ADDENDA NUMBER (1)
February 25, 2020

RFP #2020-07-011
DESIGN BUILD
SIERRA COUNTY ADMINISTRATION BUILDING

ADDITION #1 FOR IT SPECIFICATIONS

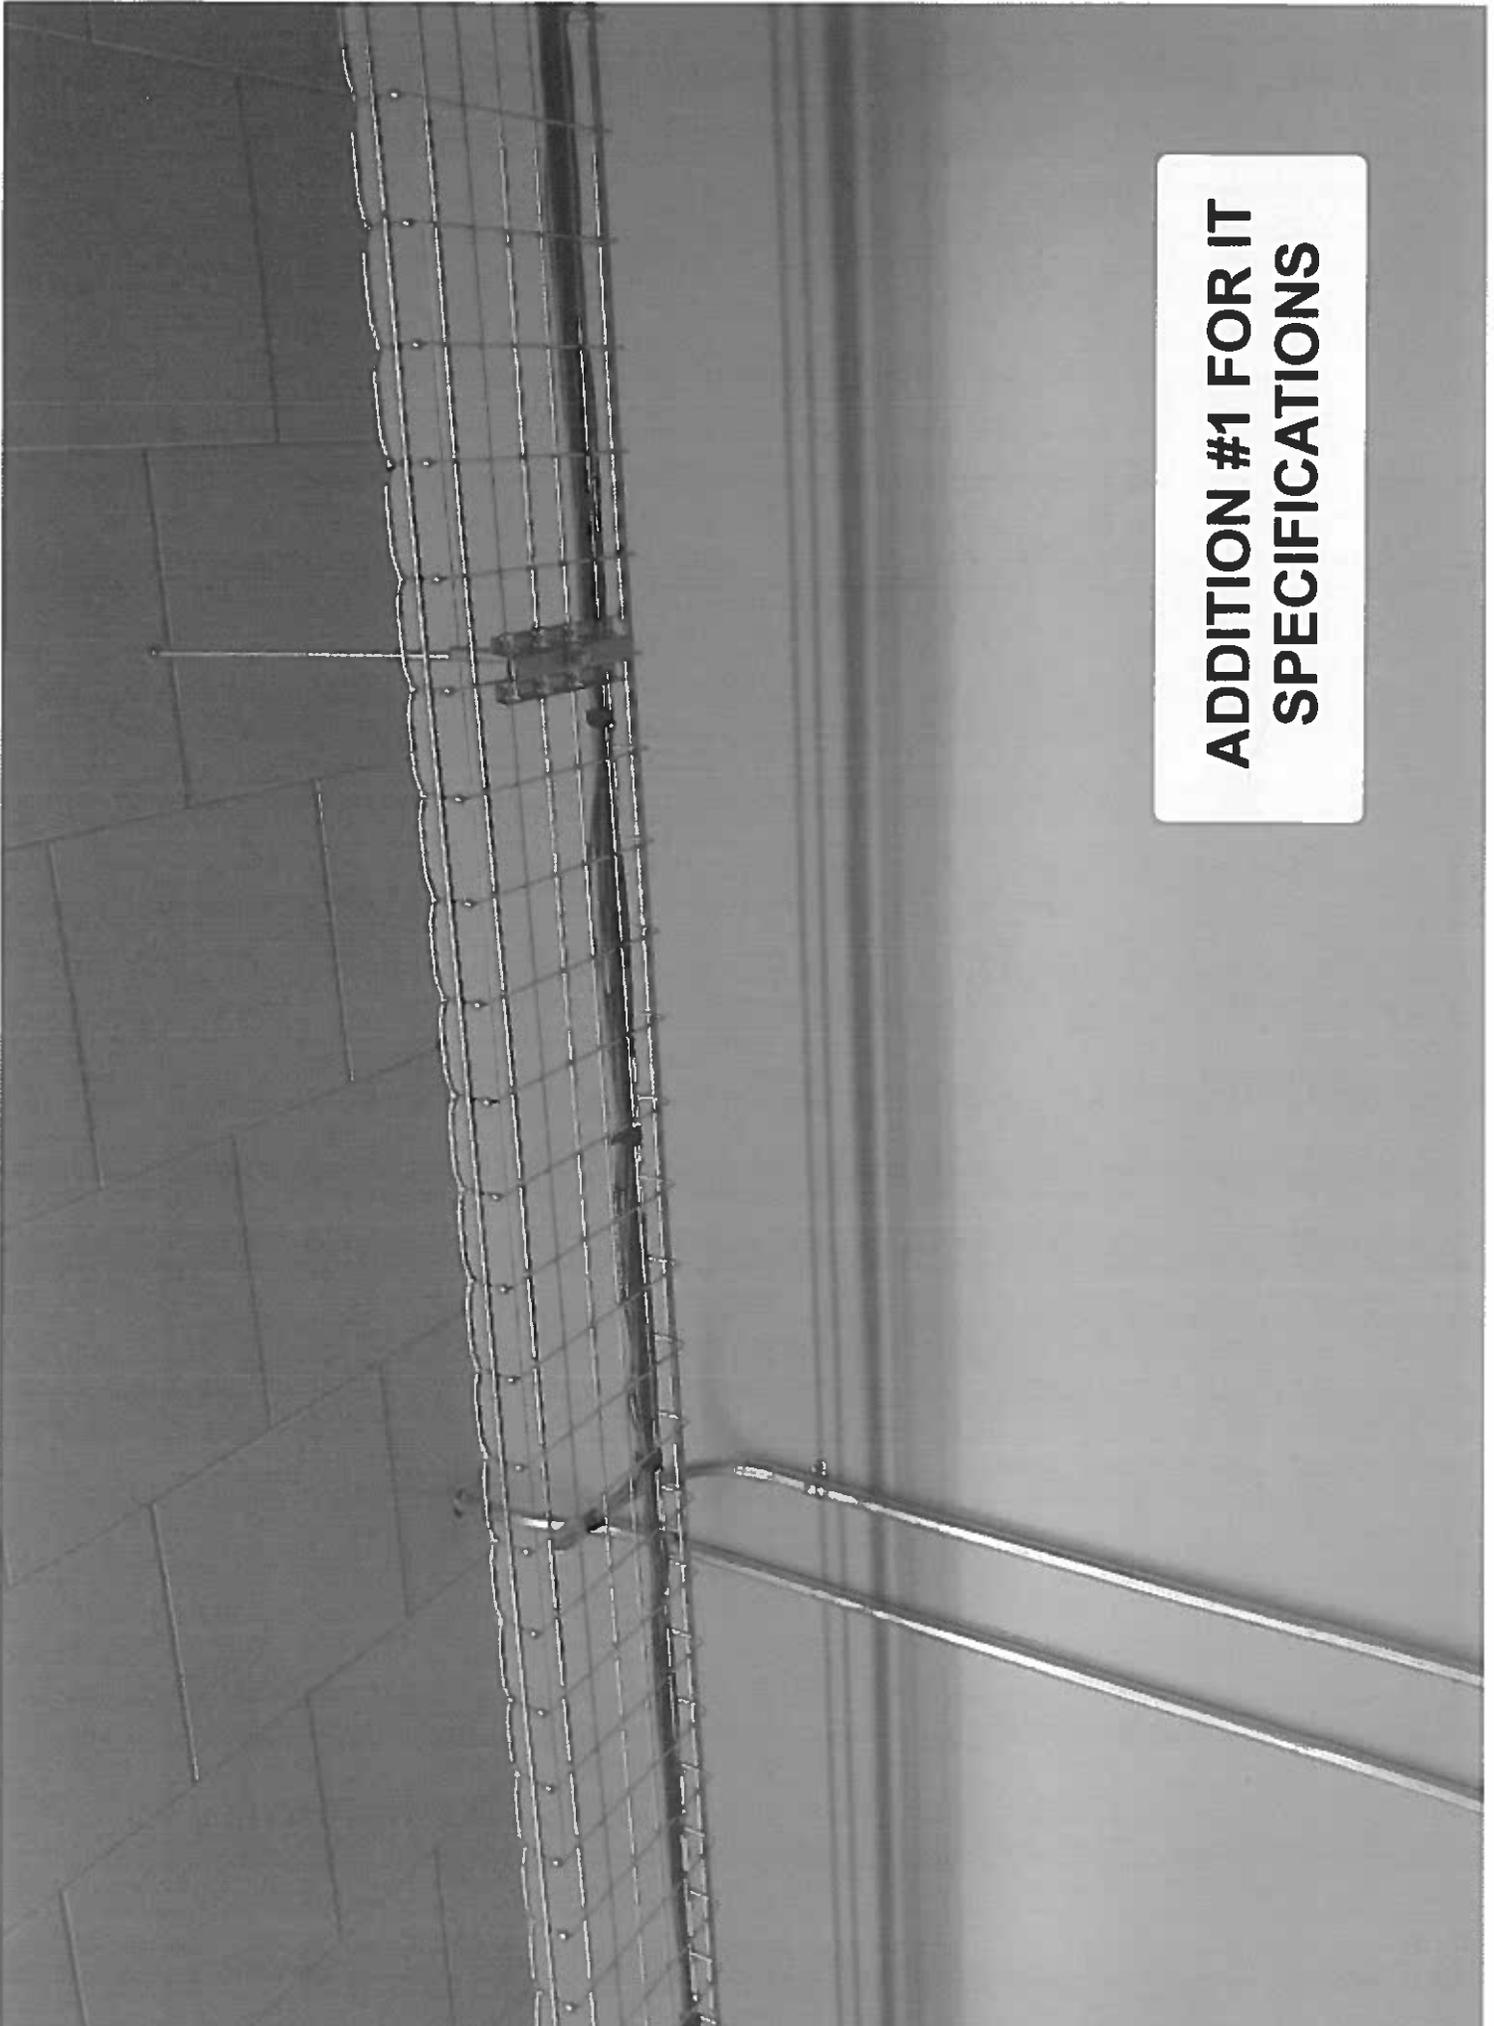
8. All wiring that is not contained in a closed pathway (conduit, cable tray, etc.) must be supported by J-supports above the ceiling:

- Under no circumstances can horizontal pathways be cable tied, cinched to existing false ceilings or laid upon the ceiling tile.
- All cables must be bundled and or supported by Approved Reusable Hook, Loop Cable Ties or Velcro. Nylon tie wraps are NOT acceptable.

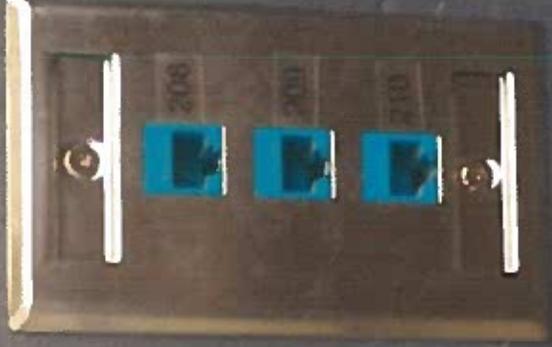
See attached photos:
